Service Bulletin No: 32-028

Modification No: EC-17-0397

**LANDING GEAR - WHEELS AND BRAKES
REMOVAL OF THE BONDING STRAP FROM THE LEFT AND RIGHT BRAKE-PEDAL
INTERCONNECTING TIE-RODS****1. Planning Information****A. Effectivity**

Brake-Pedal interconnecting Tie-Rod - Bonding Strap Removal
Figure 1 (Sheet 1 of 3)

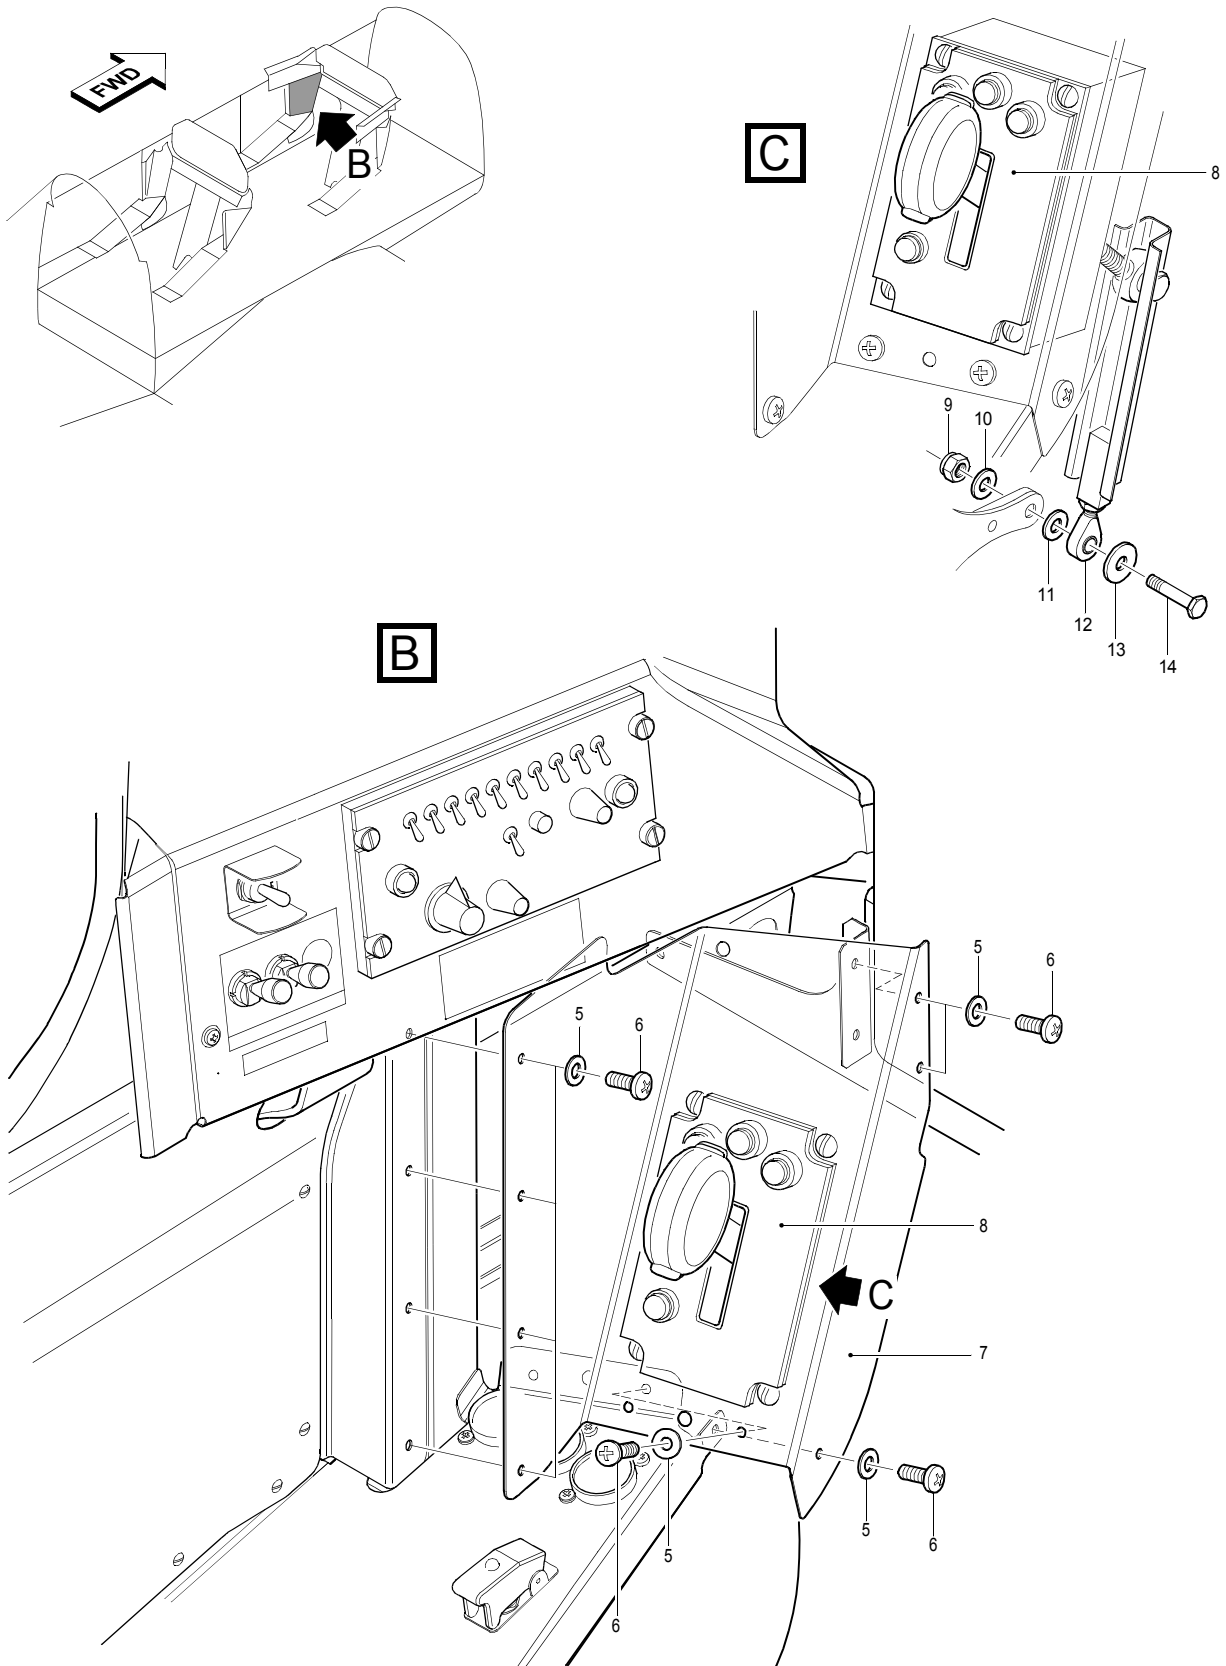
- (5) Get access to the right interconnecting tie-rod in the front cockpit (Ref. Fig. 1, Sheet 1 and Sheet 3):
 - (a) Remove the CWS annunciator panel (3) (Ref. AMM 31-51-22, Page Block 401).

NOTE: The RH front side panel (4) may have customer specific equipment installed.
 - (b) Remove any customer specific equipment as necessary from the RH front side panel (4). Make a note of the equipment removed.
 - (c) Remove and keep the screws (2) and washers (1) from the RH front side panel (4).
 - (d) Move and temporarily hold the RH front side panel (4) sufficiently clear of the work area to get access to the bonding strap (18) on the right interconnecting tie-rod (15).

- (1) Close the access to the right interconnecting tie-rod in the front cockpit (Ref. Fig. 1, Sheet 1):
 - (a) Put the RH front side panel (4) in position for installation.

- (b) Install the screws (2) and washers (1) in the RH front side panel (4).
 - (c) Install the CWS annunciator panel (3) (Ref. AMM 31-51-22, Page Block 401).

Brake-Pedal interconnecting Tie-Rod - Bonding Strap Removal
Figure 1 (Sheet 3 of 3)

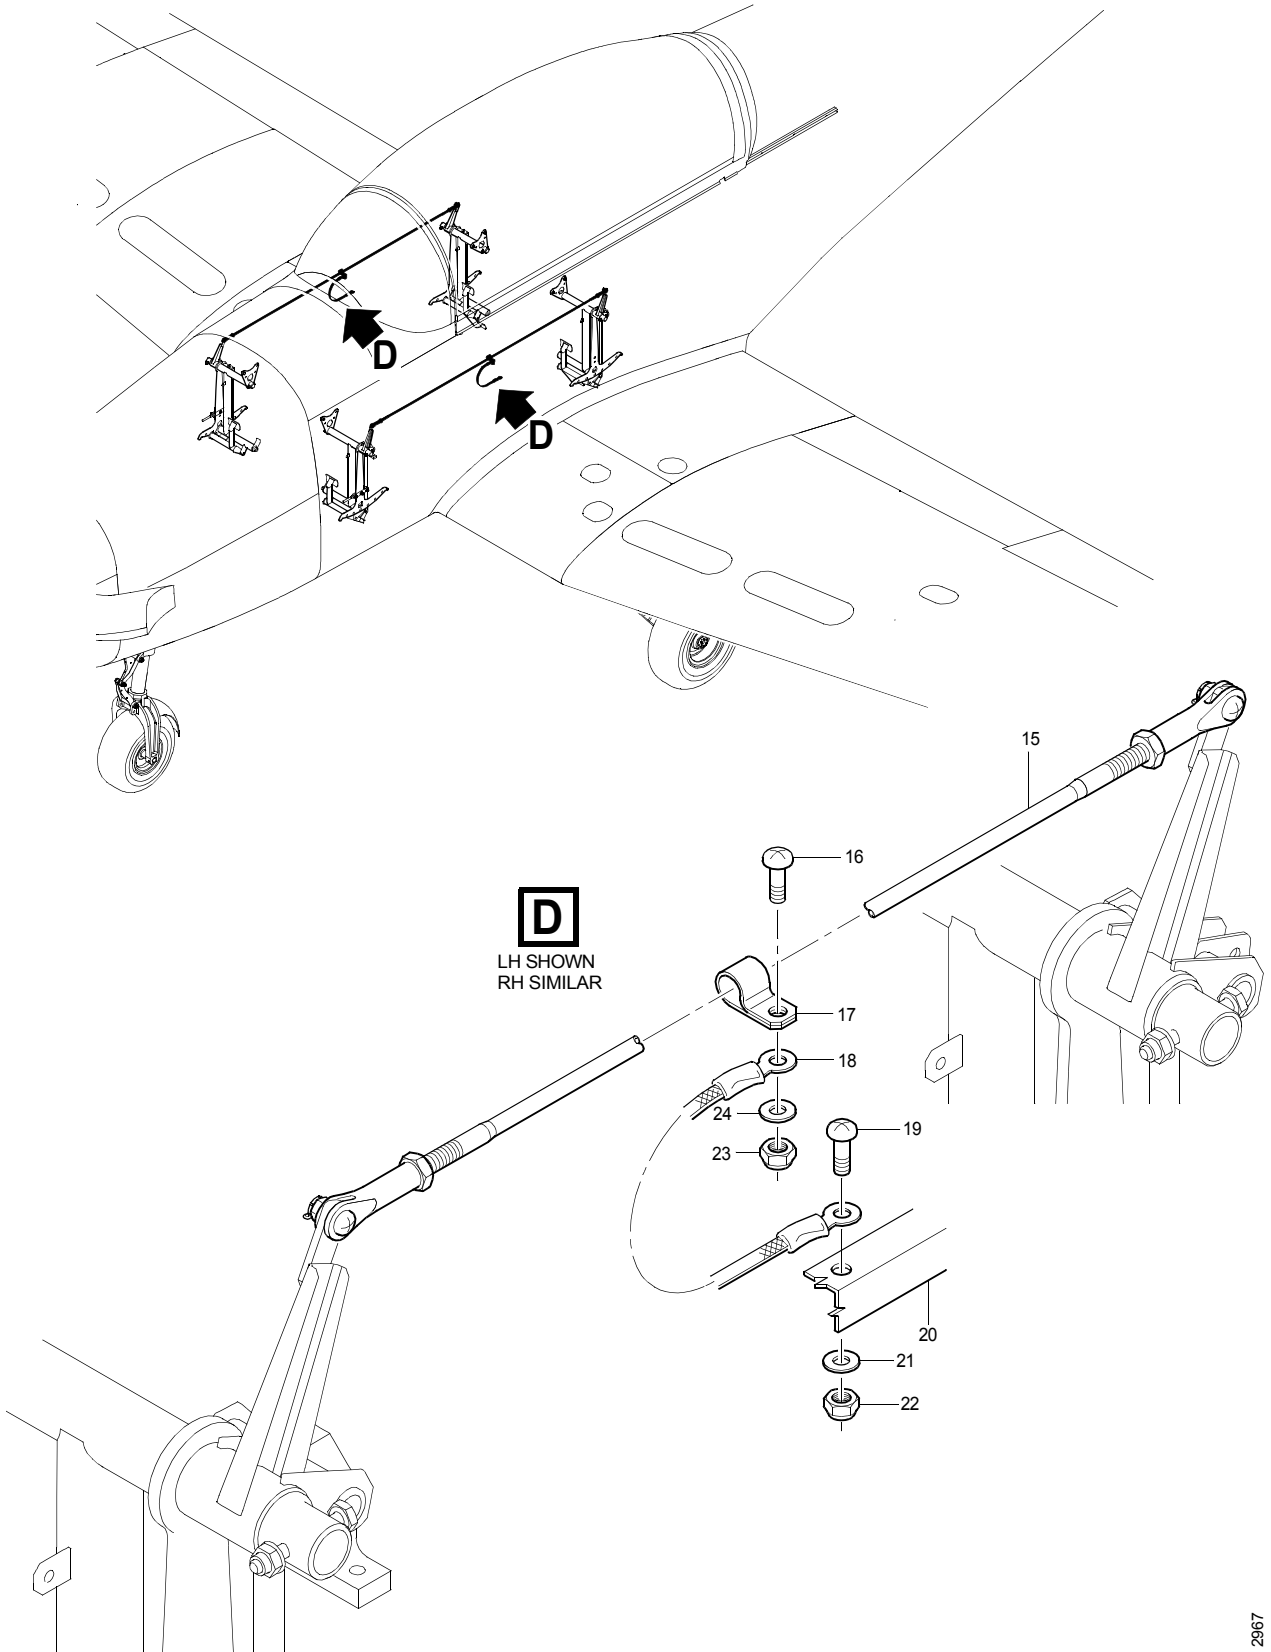
- (1) Remove the bonding strap from the left interconnecting tie-rod (Ref. Fig. 1, Sheet 3):
 - (a) Remove and discard the nut (23), the washer (24) and the screw (16).
 - (b) Remove and discard the P-clip (17) from the interconnecting tie rod (15).

- (c) Remove and discard the nut (22), the washer (21), the screw (19) and bonding strap (18).
- (2) Remove the bonding strap from the right interconnecting tie-rod (Ref. Fig. 1, Sheet 2):
 - (a) Remove and discard the nut (23), the washer (24) and the screw (16).
 - (b) Remove and discard the P-clip (17) from the interconnecting tie rod (15).
 - (c) Remove and discard the nut (22), the washer (21), the screw (19) and bonding strap (18).
- (3) Restore the surface protection in the area of the removed bonding straps (18) on the left and right stringers (20) (Ref. SRM 51-70-15).

The bonding straps and attachment hardware are removed from the left and right brake-pedal interconnecting tie-rods.
